**TOWN OF HERNDON, VIRGINIA  
ARCHITECTURAL REVIEW BOARD  
WORK SESSION AGENDA  
MARCH 6, 2019  
HERNDON COUNCIL CHAMBERS BUILDING  
765 LYNN STREET  
7:30 P.M.**

1 NORTH ELEVATION - NEW

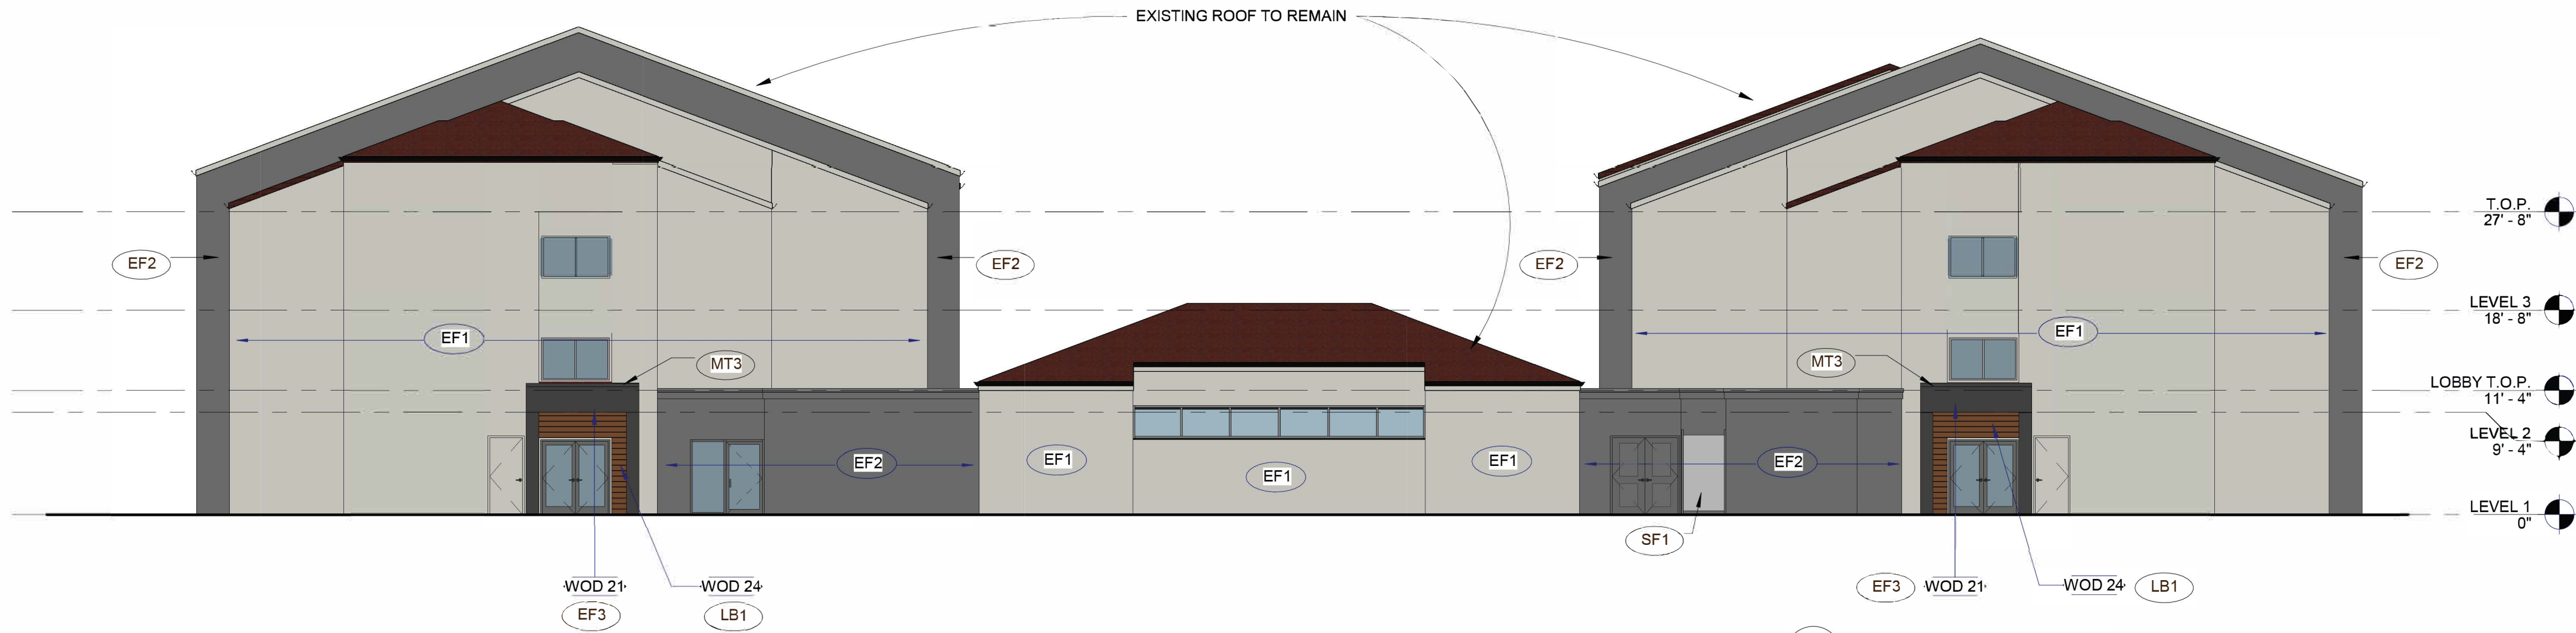
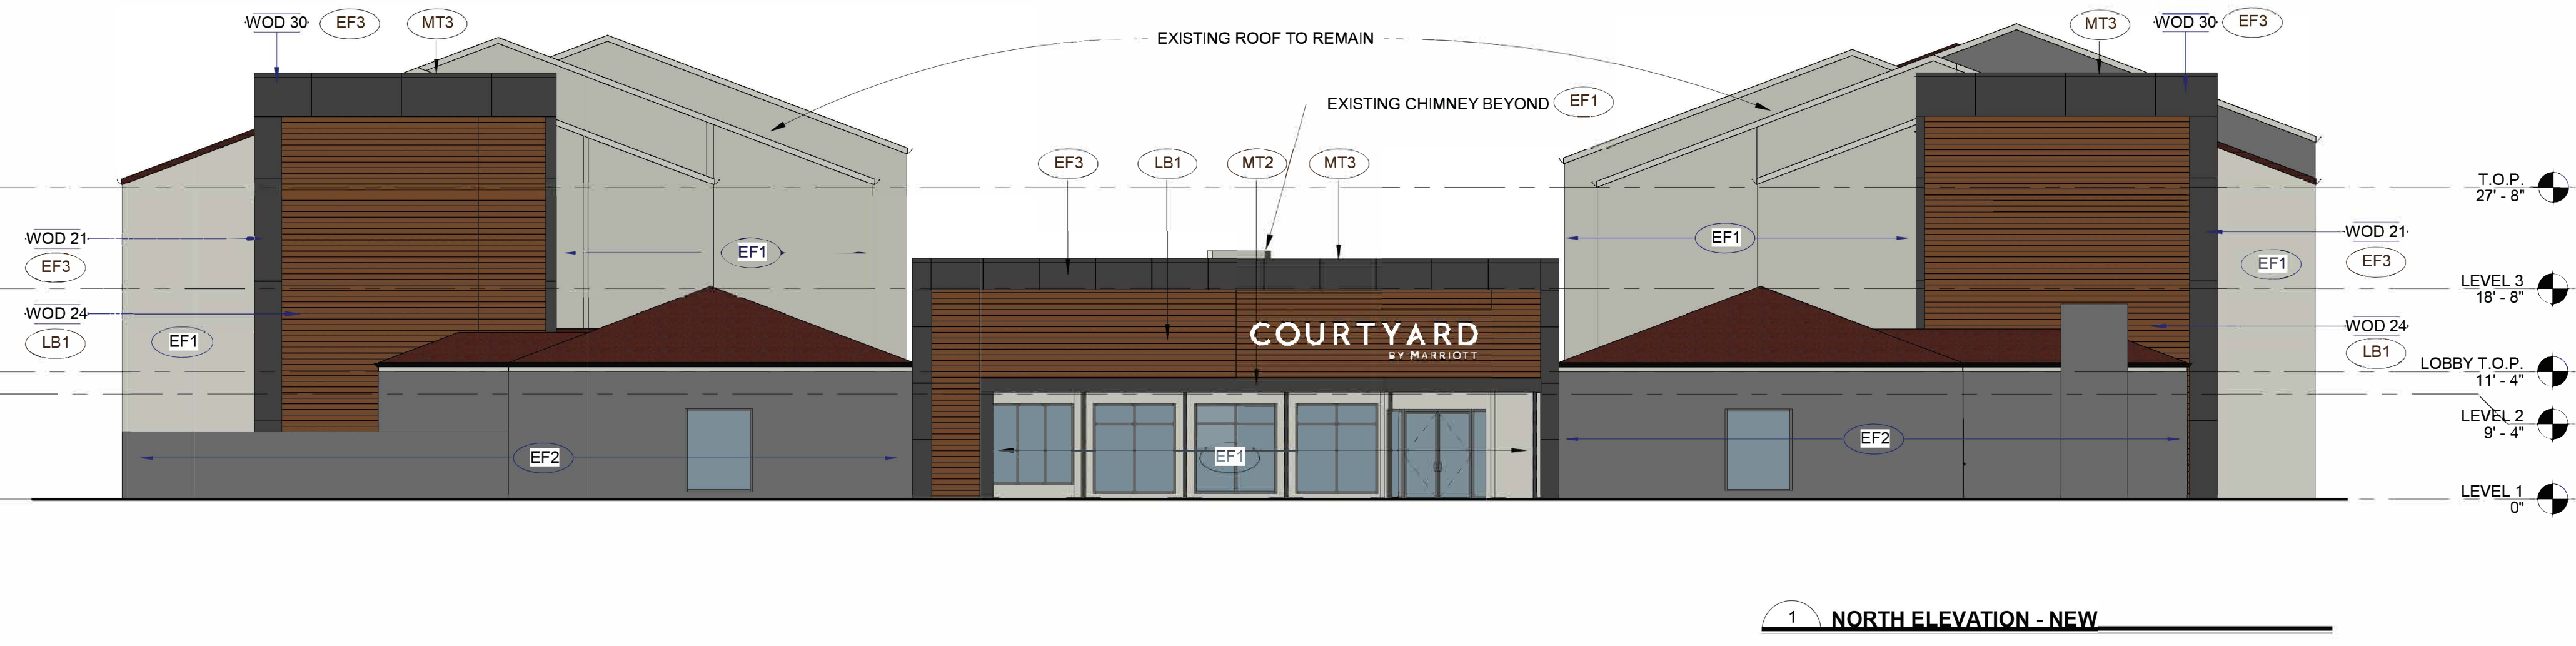
3. The architectural rendering of the north elevation on Sheet P200 of the Submission (Attachment #5) shows what appears to be some sort of mechanical feature on the roof. Staff will require clarification of this drawing feature. Should the object in the drawing be a mechanical system component, this feature will be subject to the Town's Zoning Ordinance Section Sec. 78-114 – Screening.

**Response:** The projection seen on Sheet P200 rendering is the back side of the existing chimney, on the courtyard side of the lobby. This can be seen on 1/P201 North Courtyard Elevation -New. This feature is now called out on 1/P200 North Elevation – New. It will be painted EF1 as indicated on 1/P201.

**Response:** The dumpster is located at the loading dock and is enclosed by screen walls. The North side is shown on 1/P200 North Elevation – New. The East side is shown on revised 2/P200 East Elevation – New. The existing chain link gate will receive new gray slats. The chain link mechanical screen on the South side of the building, which is called out on revised 3/P200 South Elevation – New, will also receive new gray slats. See revised P200 sheet, detail 8/P208 for photos of existing and cut sheet for slats.
